E	12/03/12	Section 75W Submission	PL	MD
D	04/11/11	Revised Design following SOPA comments	JC	MD
B	09/09/11	Revised Design following SOPA comments	MD	MD
A	06/04/11	DA Submission	JL	MD
Revision	Date	Description	Initial	Checked

Site 3
Sydney Olympic Park
Plan
Basement 001

Site 3
Sydney Olympic Park
Elevation
West Elevation

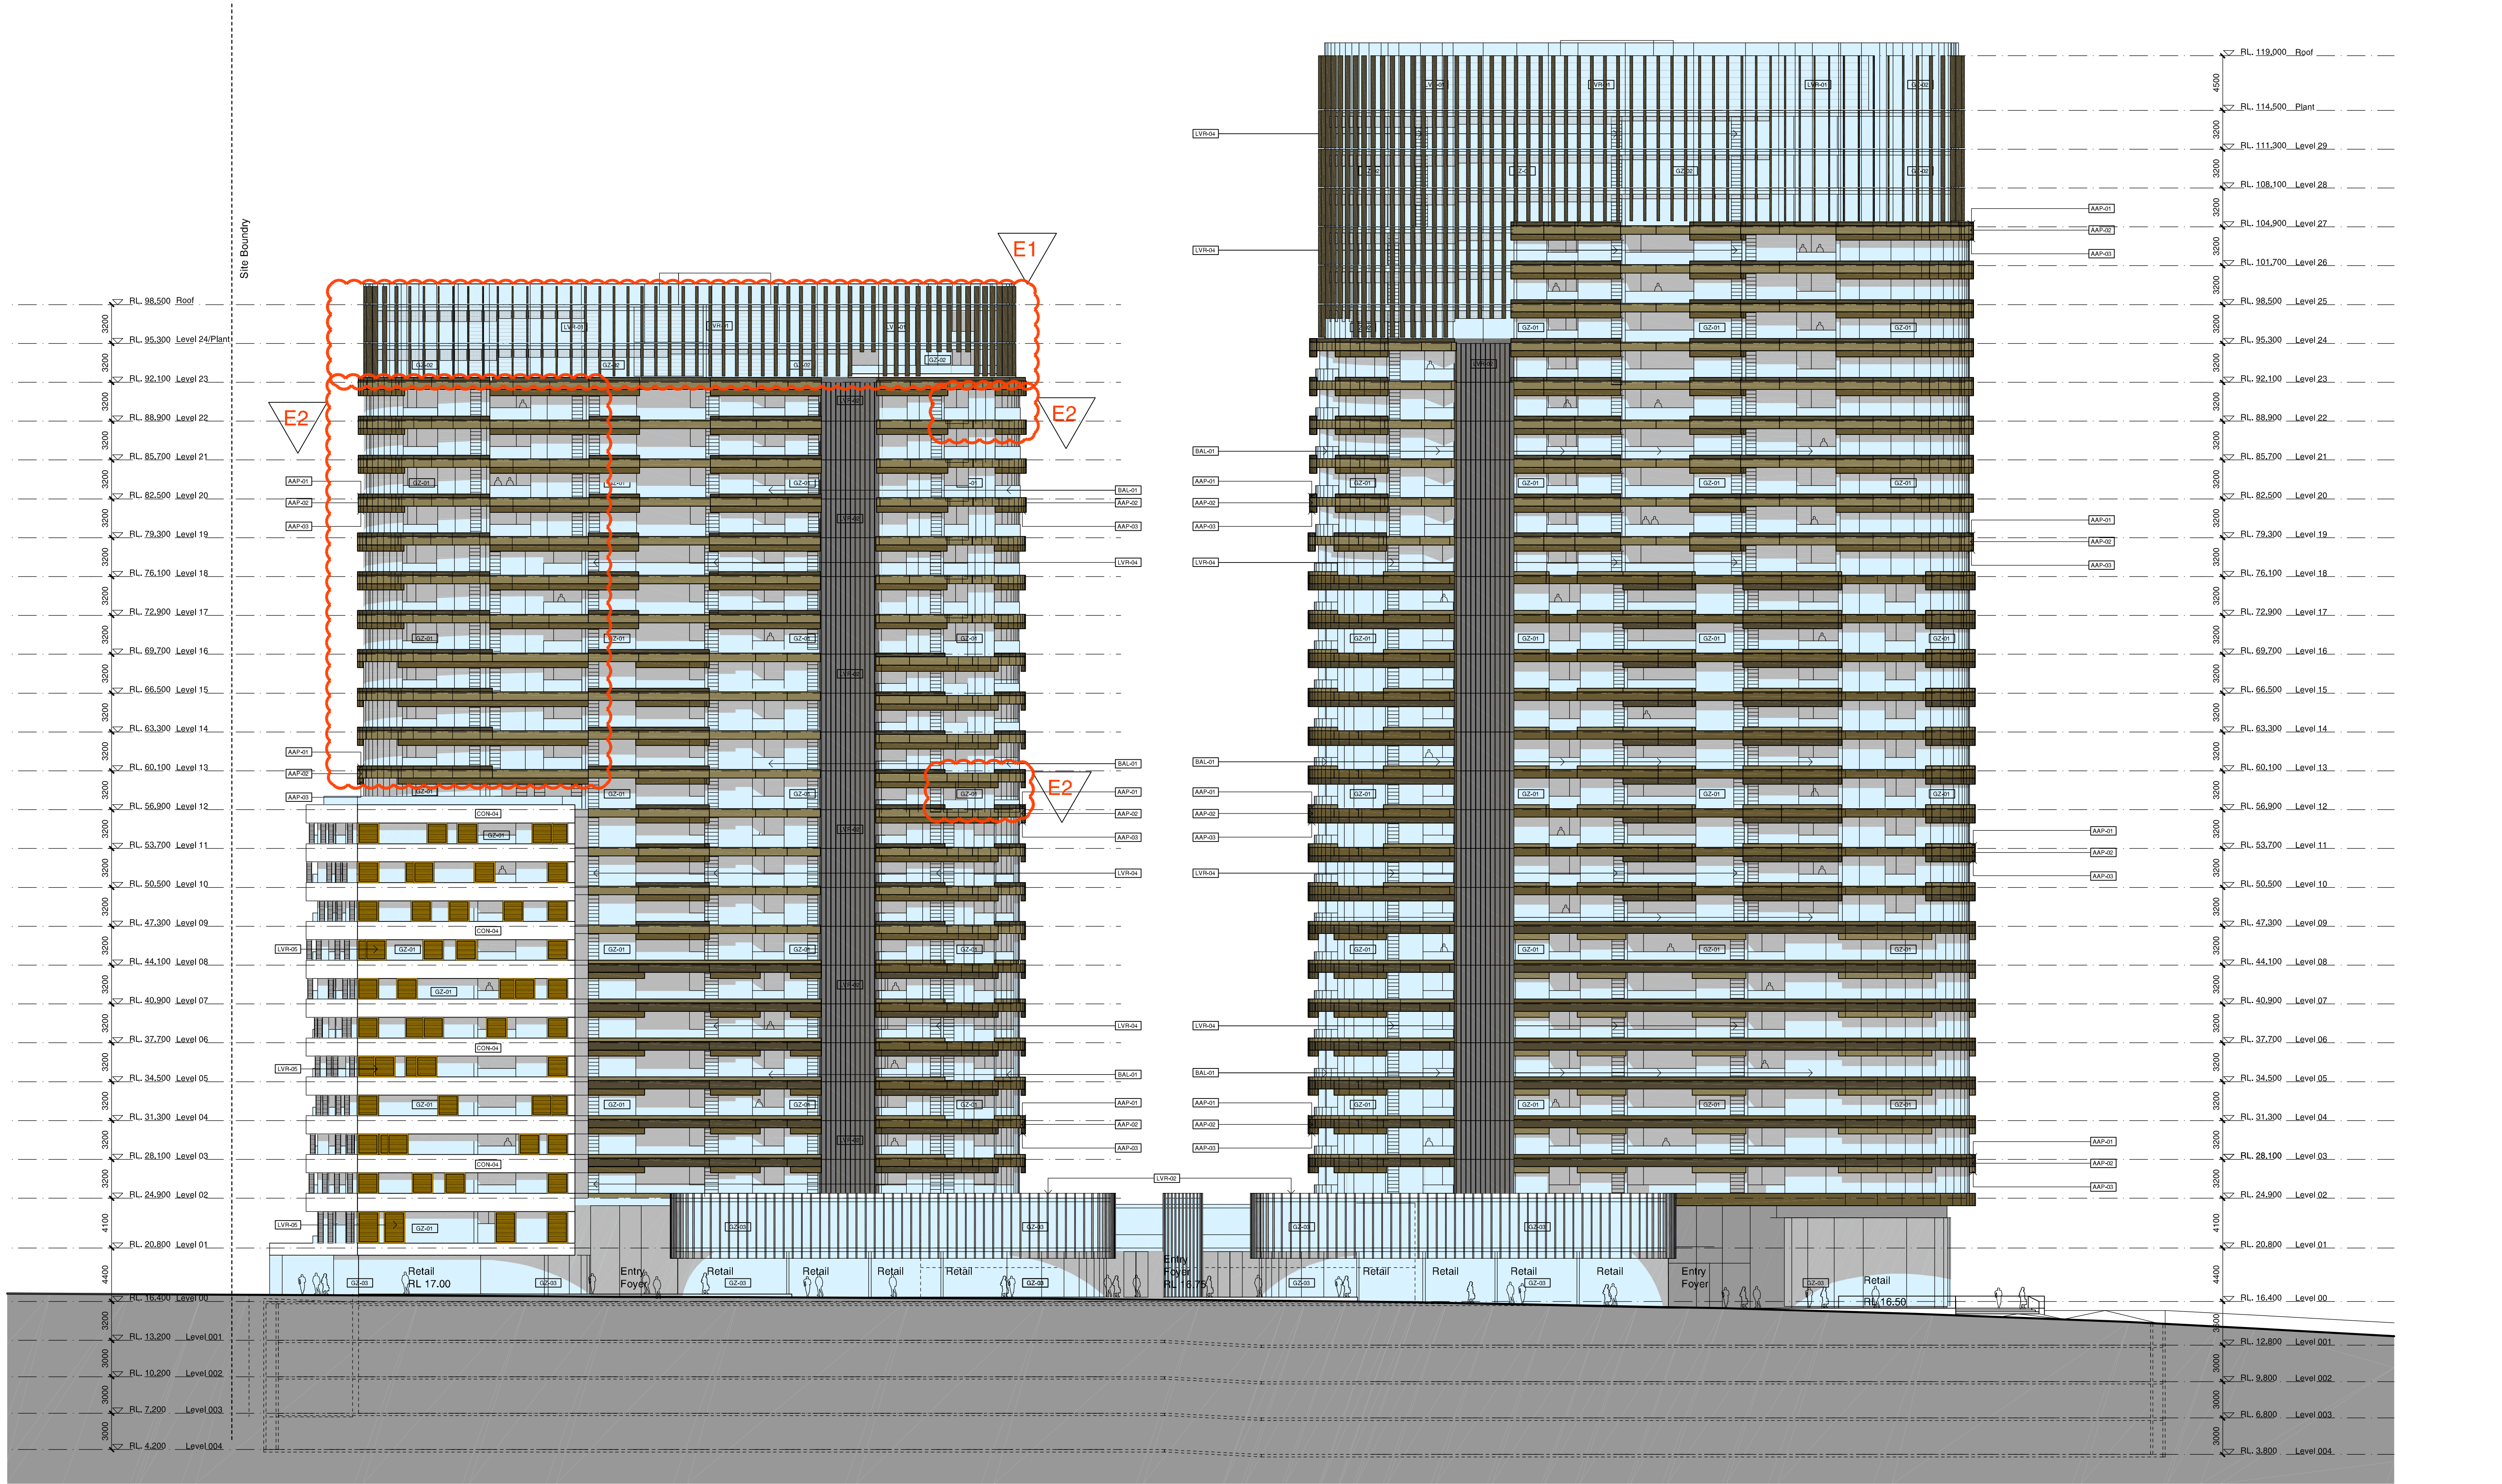
Revision E - Section 75W Amendments.
1. Loft apartments modified to single storey apartments on Level 23 & 24. Elevation amended to match current plans.
2. Elevation amended to match current plans.

Site 3
Sydney Olympic Park
Elevation
East

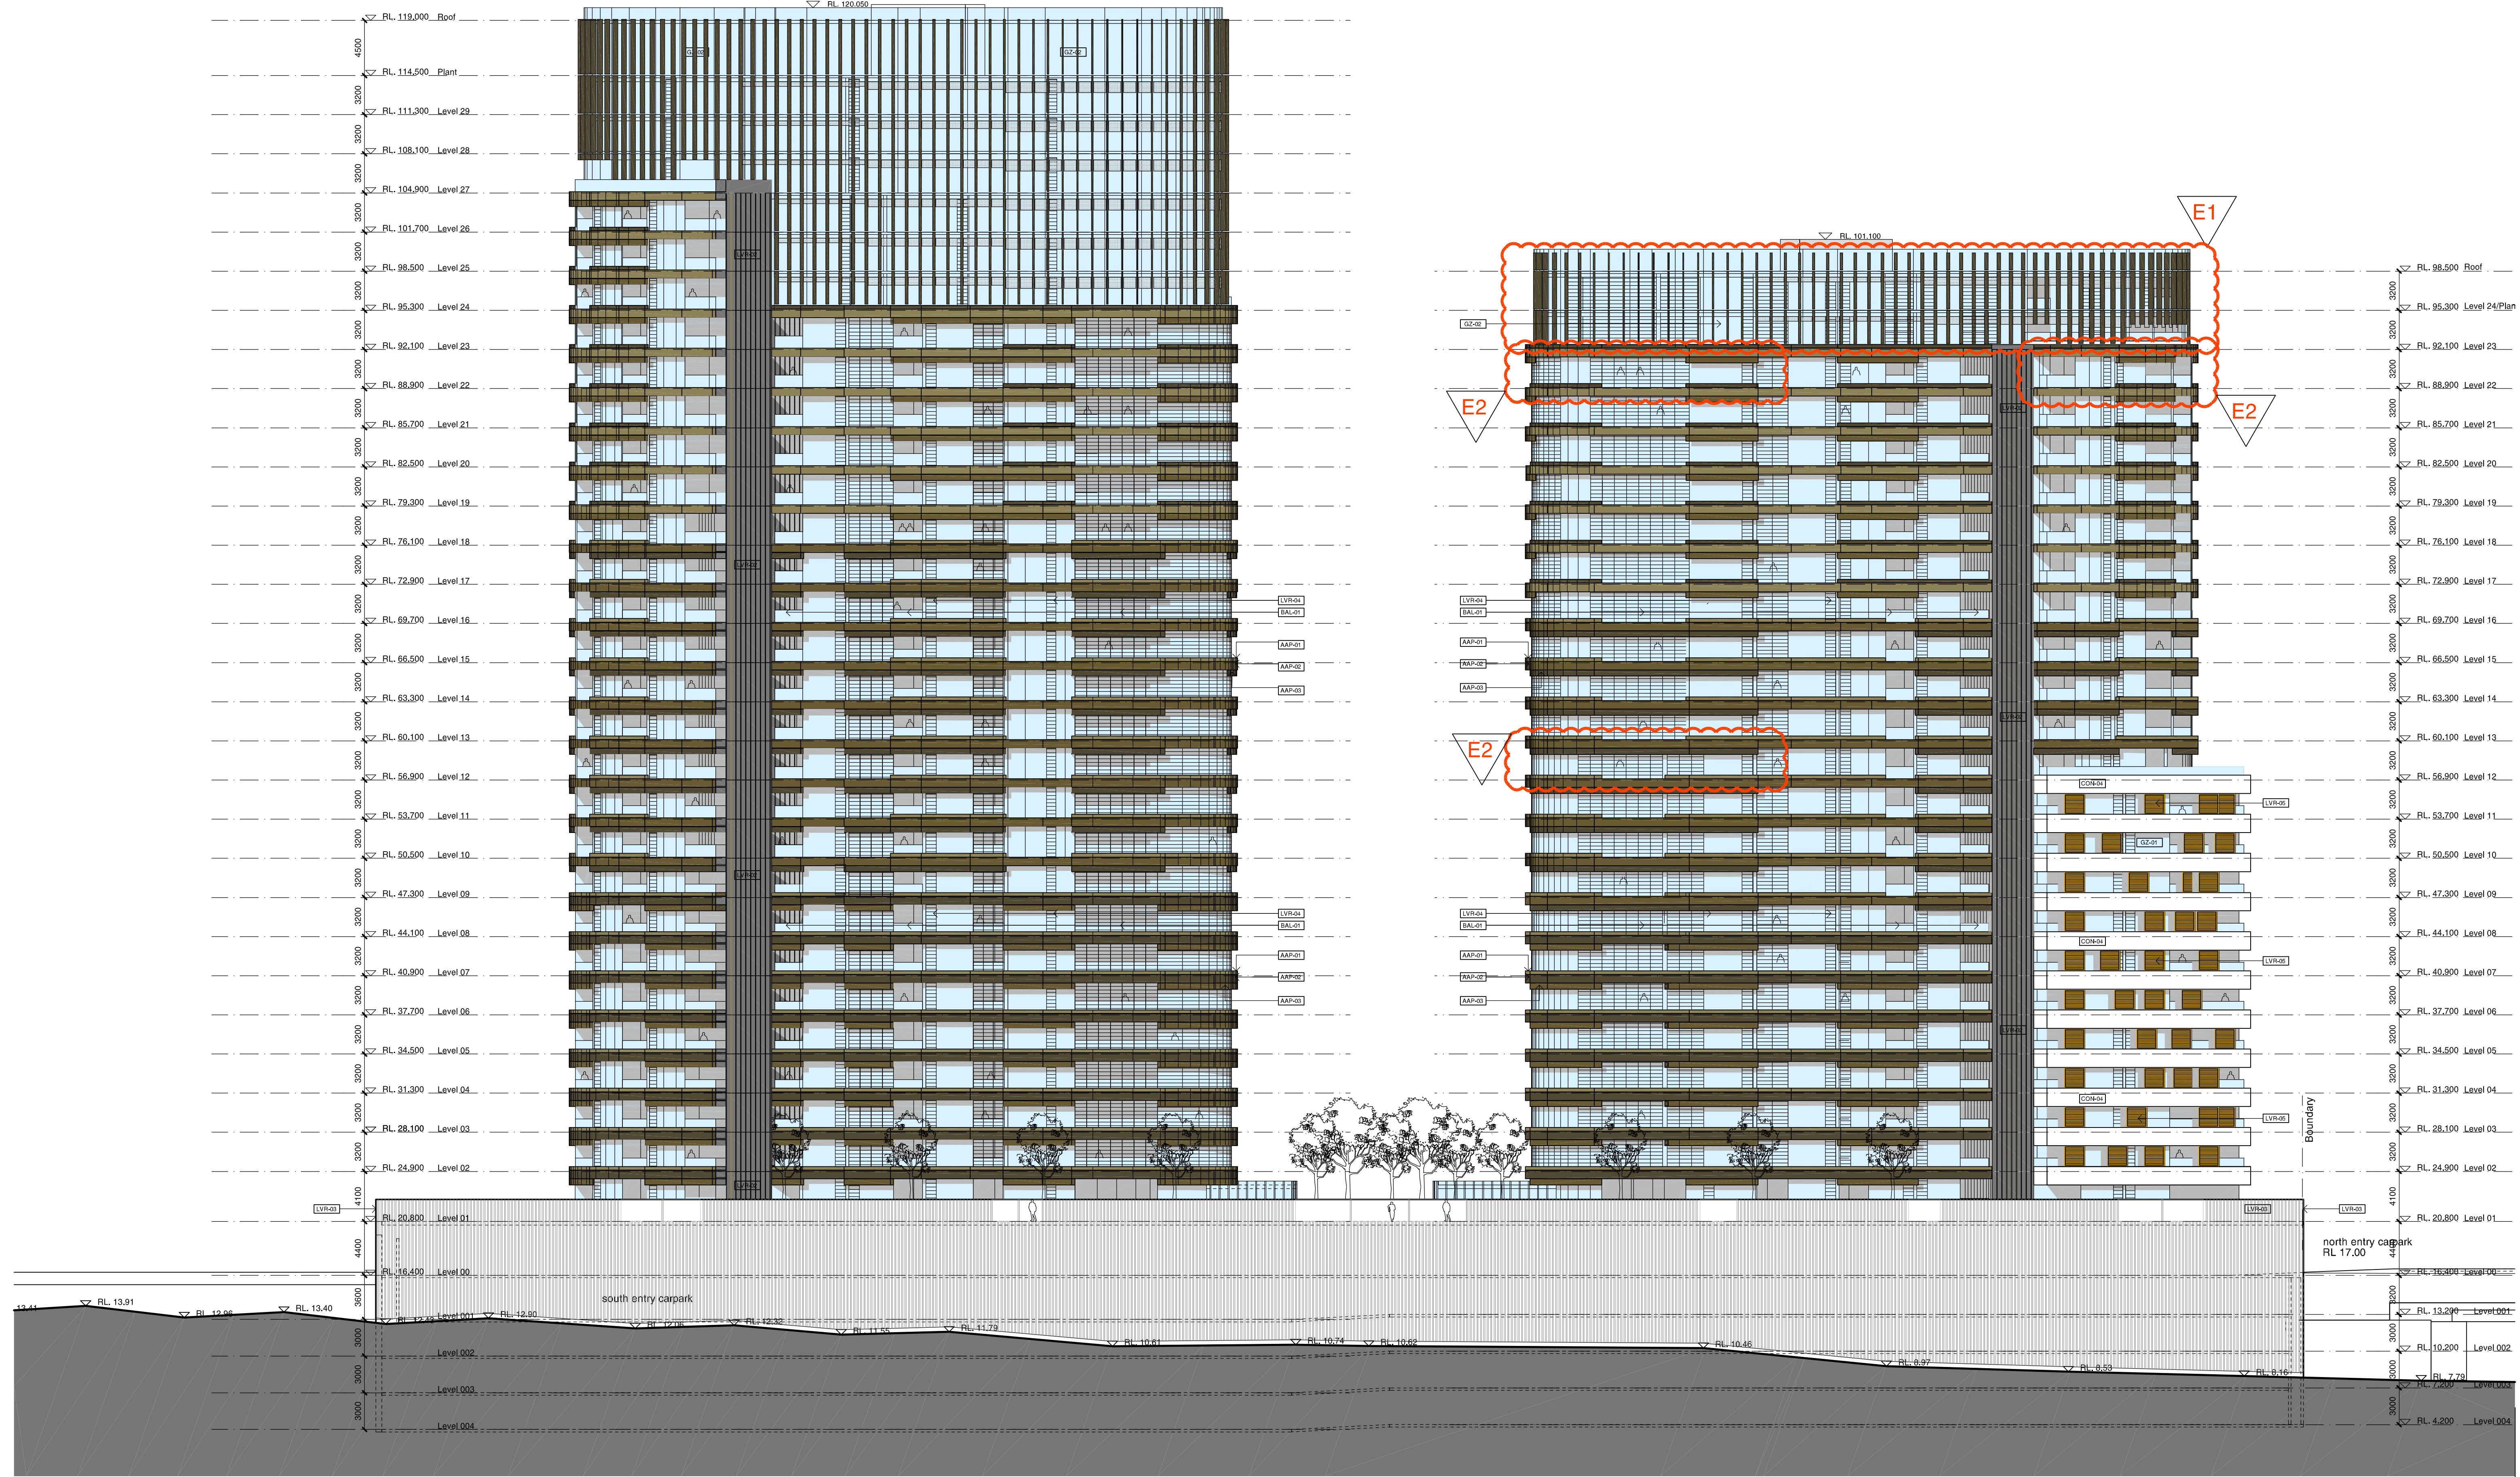
Revision E - Section 75W Amendments.
1. Loft apartments modified to single storey apartments on Level 23 & 24. Elevation amended to match current plans.
2. Elevation amended to match current plans.

Site 3
Sydney Olympic Park
Section AA

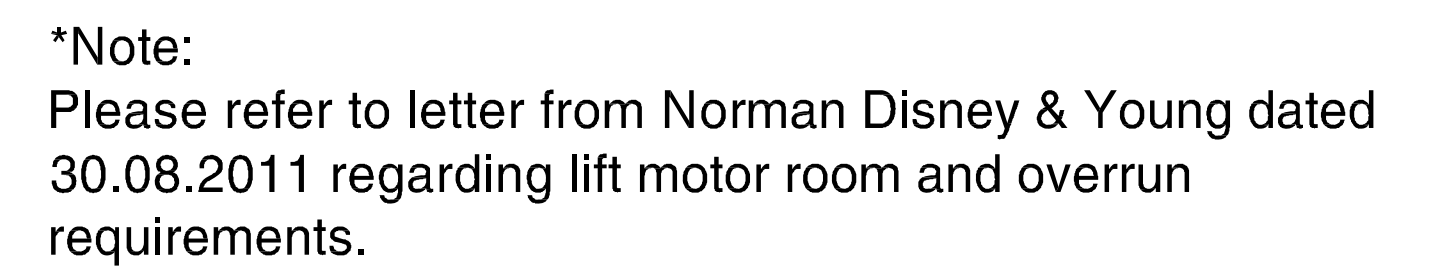
1. Loft apartments modified to single storey apartments on Level 23 & 24. Lift access has been extended to serve Level 24 apartments.
